Re: Duntroon Quarry Expansion Hydrogeological Peer Review Comments
Response to Supplementary Karst Review Comments from Daryl Cowell, P.Geo
File 04 930521.52

**PROPOSED DUNTROON EXPANSION
LEVEL 2 HYDROGEOLOGICAL ASSESSMENT ADDENDUM REPORT
(October 2007)
RESPONSE TO SUPPLEMENTARY KARST PEER REVIEW QUESTIONS**

GROUNDWATER FLOW DIRECTIONS WITH PROPOSED EXPANSION AND EXISTING QUARRY LAKES

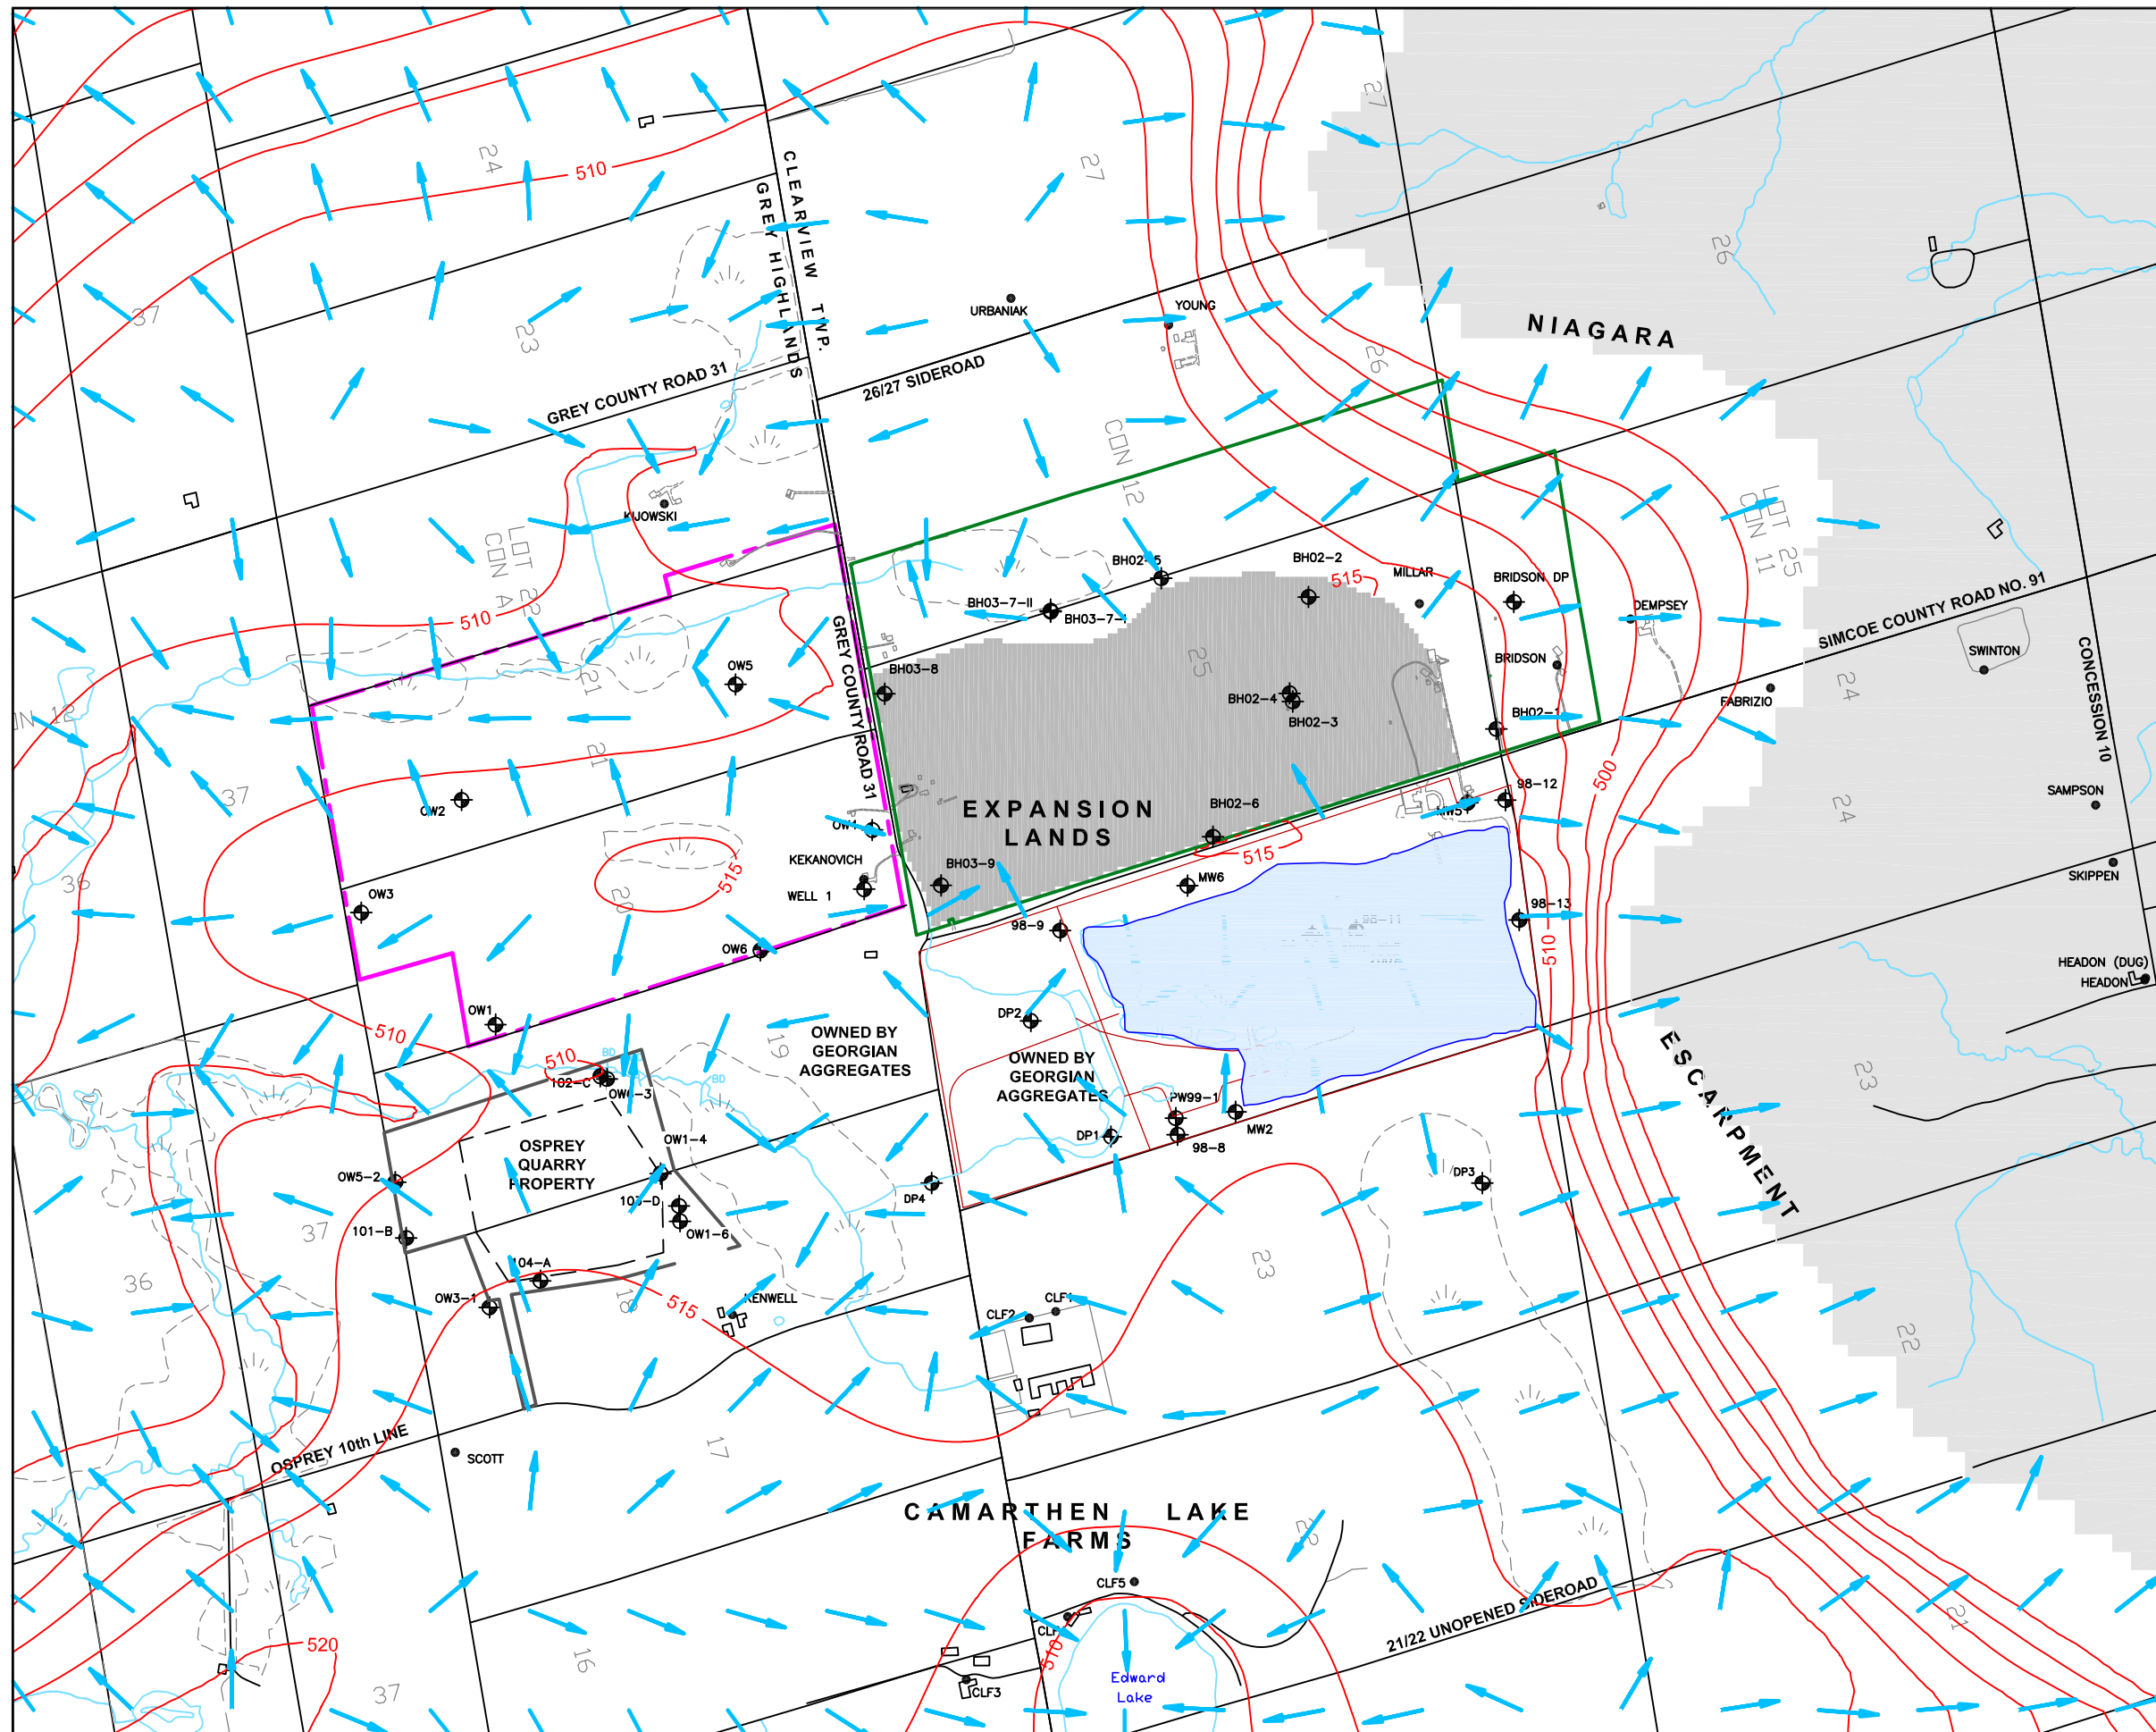
1. Confirmation of the parameters and modelling associated with the filling of the expansion quarry (based on parameters in Table 5-14 of the Jagger Hims Limited 2007 addendum hydrogeological report.
2. The large anisotropic lineament to the north of the MAQ and expansion quarry extraction areas. This may be associated with high K-values identified for the NW corner of the latter which is affecting the outflow volumes noted in (1) above. The feature should be better-quantified and may require some further assessment of the MAQ quarry modelling and collaboration with the Jagger Hims modelling. Additional pumping tests/slug tests may be required?

Figure 1 shows groundwater flow directions in Layer 3 of the model near the bottom of the existing quarry lake. Groundwater flows into the existing quarry lake from all sides except on the east side where there is flow eastward to the Niagara Escarpment. Groundwater flows into the expansion lake from the southwest and west with minor inward flow from the east side. Groundwater then flows northeast and north to exit the lake on the north side from where it flows westward. There is a minor component of groundwater flow from the lake northeast to the Niagara Escarpment.
